**TOWN OF LEESBURG
TOWN COUNCIL WORK SESSION STAFF REPORT**

SUBJECT: TLZM-2012-0003, Crescent Place a concept plan and proffer amendment and rezoning application.

UPDATE: On November 19, 2013 the Applicant provided a working draft of a revised concept plan and, for Buildings D and E, revised building elevations and a cross-section Staff has not had the opportunity to fully review and comment on the working draft documents, but notes the following changes to the plan, tabulations, and building architecture. (See attachments 1-3)

CONCEPT PLAN
CRESCENT PLACE
ZONING CONCEPT PLAN & PROFFER AMENDMENT
TLZM-2012-0003
TOWN OF LEESBURG
LOUDOUN COUNTY, VIRGINIA

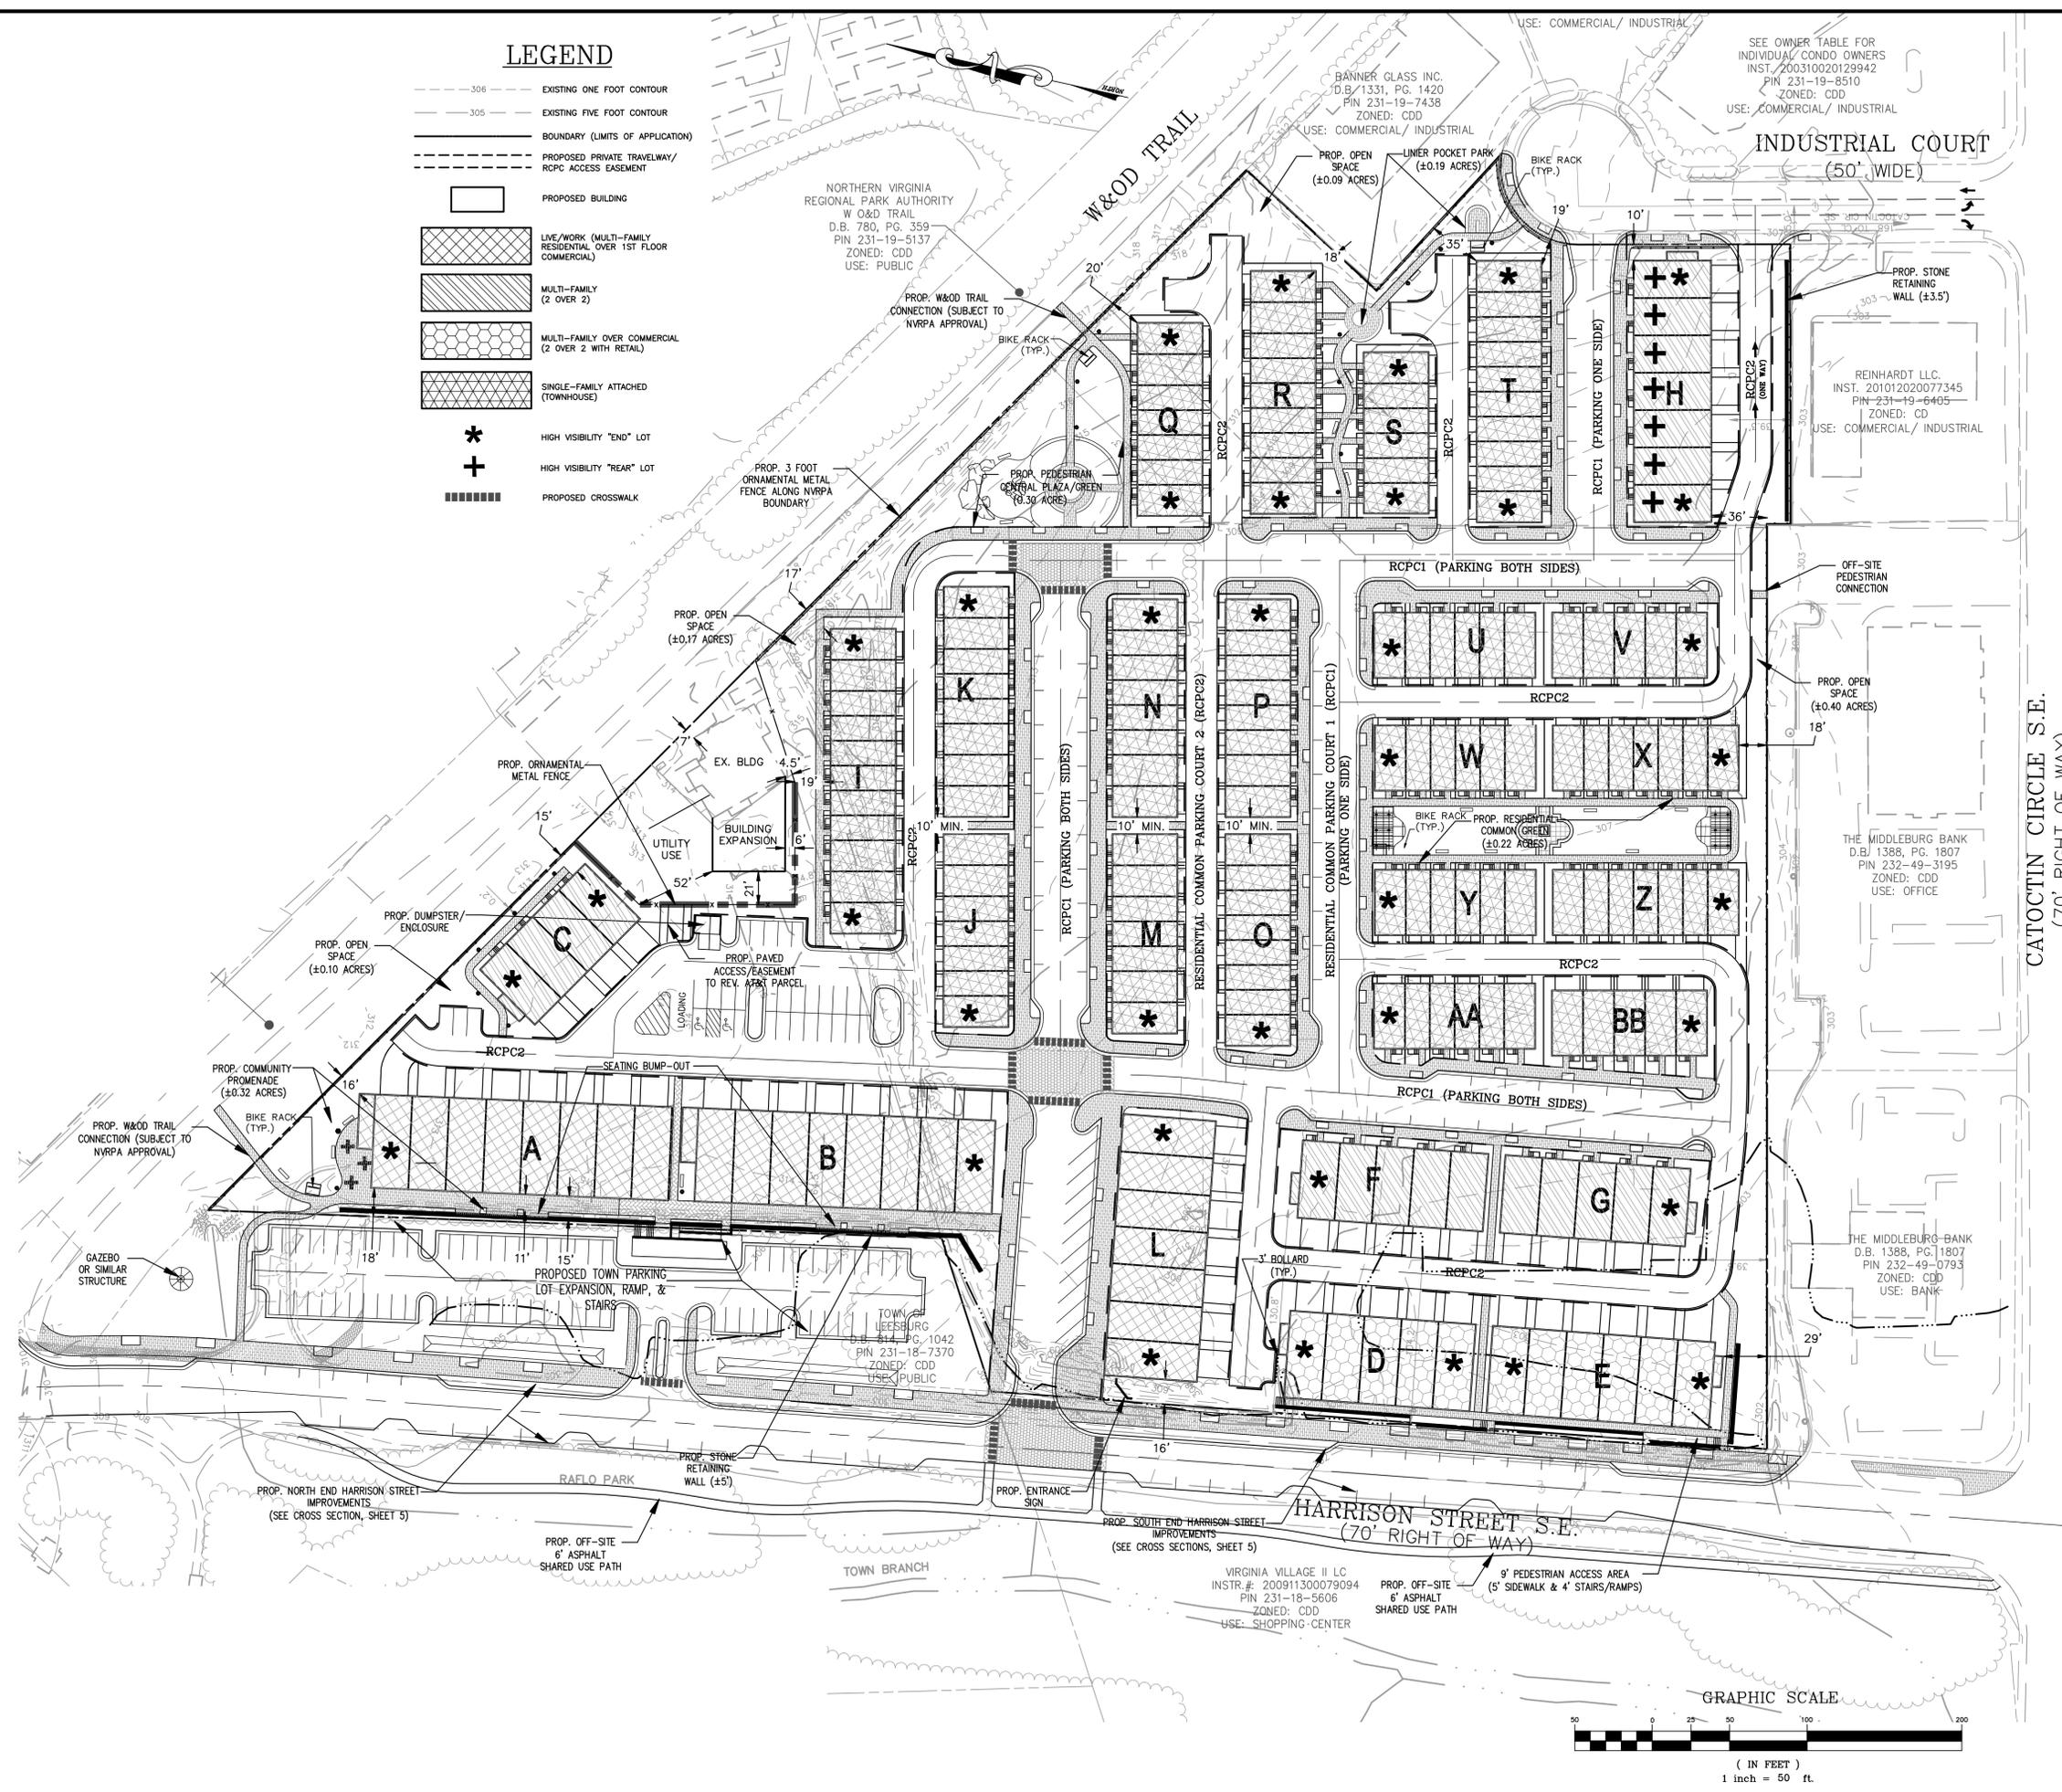
- **Residential Density:** In order to maintain some flexibility during the final site planning of the project, the Applicant is revising the residential density to 230 dwelling units as originally proposed. Although 224 dwelling units are depicted on the plan, the overall composition of dwelling unit types has not been finalized. Therefore, flexibility is sought in the total number of dwelling units and not any specific dwelling type.
- **Commercial Square footage:** The Applicant's intent is to revise the proposal to increase commercial square footage from 16,000 to a maximum of 35,000. The revisions to date currently depicts 33,500 square feet (see Attachment 1), but the Applicant is continuing to explore ways to increase that amount. Changes to building commercial square footage include:

- **Commercial Parking Calculation:** As a result of the additional commercial square footage, the commercial parking calculation has been revised. A table is provided below to illustrate the required and provided parking tabulations. Due to the fact that the Applicant is still revising the plan, Staff made the following assumptions regarding required parking, see the notes below the table.

Per Town of Leesburg Zoning Ordinance (TLZO Sec. 11.2, the Applicant cannot satisfy the required on-site parking requirement of 151 spaces. A modification of 104 commercial parking spaces is required. However, there are a number of “off-site” adjacent parking spaces located on the Town Parking Lot and Harrison Street (adjacent to the specified Buildings above) that could be used to justify the requested modification. These spaces are identified in the column above entitled “With Adjacent Parking included.” If credited these 49 spaces would reduce the overall parking deficiency from 104 spaces to 56.

- **Open Space:** An essential element of the Crescent District Master Plan (CDMP) is street connectivity. The CDMP was modified to eliminate a vehicular connection across the W&OD Trail; however, public street connections through the Crescent Place property remained. The Boulevard depicted on previous versions of the concept plan was intended to implement the CDMP objective regarding connectivity; but it had one compliance issue in that it was not a public street. However, because of the design features proposed as part of the boulevard (wide sidewalks, on-street parking, and the more than the required street tree plantings), Staff supported this centrally located, unifying design element as compensation for a publicly maintained street. This feature, which included open space, has been eliminated from the plan.

As a result, Staff continues to believe that a modification of the required open space is necessary. TLZO Sec. 8.4.8 requires 15 percent or 1.76 acres of open space, as an infill development. Eliminating buffer-yards, as they are significantly less than required (via another modification), Staff includes the following areas as meeting intended open space:

The resulting open space (0.83 acres or 7% of the property) represents less than half of the 15% open space requirement of 1.76 acres on-site.

- **Architectural Feature, Town Parking Lot:** The Applicant has presented the idea of an architectural element at the entrance to the Town Parking lot. The Applicant is still investigating the architectural design and has not included this feature on the concept plan at this time. This architectural feature has been described as a linear pavilion-like structure. Staff notes the following concerns:

- Uses that may be associated with the structure as opposed to an architectural element
 - Maintenance of this proposed structure on Town Property
 - Location within flood plain (could need a special exception)

- New modification needed to perimeter parking lot landscaping because the structure removes required landscaping
- **Harrison Street Streetscape/Parking:** On-street parking and street trees have been enhanced along Harrison Street. Eight (8) additional parking spaces were added to the Town Parking Lot with the consolidation of the entrances to one as a median entrance. Additionally, parking bays created by street tree bump-outs increase the number of on-street parking spaces and add commentary landscaping along west side of Harrison Street.

REVISED TWO-OVER-TWO WITH RETAIL

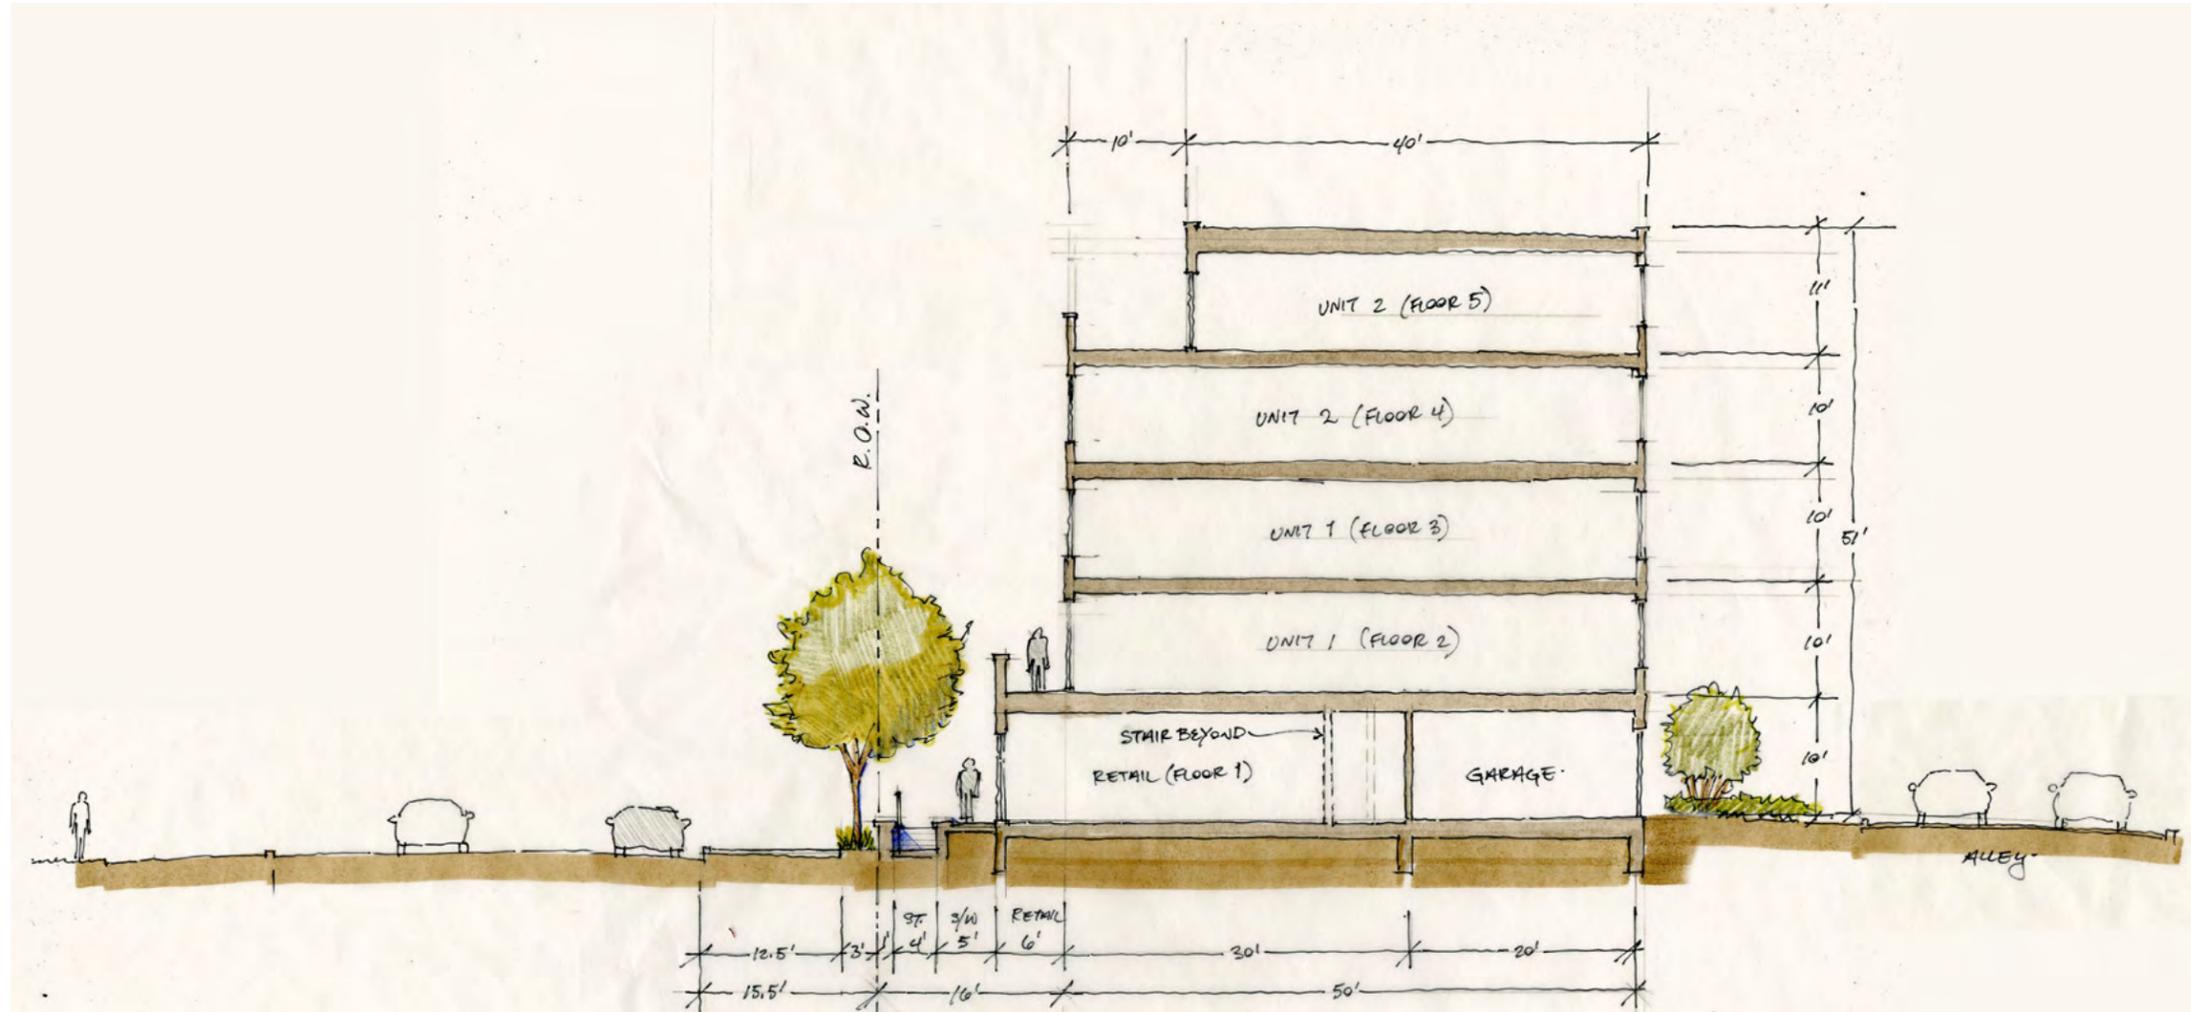
- **Building D/E Architecture/Height:** Buildings D and E have been revised to provide first floor commercial space, with a 2-over-2 residential unit above (see Attachment 2). Due to flood plain constraints and the desire to activate Harrison Street with buildings, ample pedestrian circulation and street trees, ground-level access directly to Harrison Street cannot be achieved. Multiple access points are provided along Harrison with either stairs or accessible ramps. The residential units are recessed from the lower level commercial space to create pedestrian access to the front of the unit. An elevated sidewalk, accessed from the ends of the building and located over the commercial space below, provides Harrison Street access to the elevated residential units. The addition of commercial space to the first floor increases the number of stories from four (4) to five (5), and building height increases to approximately 51 feet. Staff also notes that pedestrian access to these units is constrained via stairs on the side of the building and through internal stairwells. Access to units in Building D/E is only 5-foot wide, whereas the access to Buildings A/B is 11-foot wide.
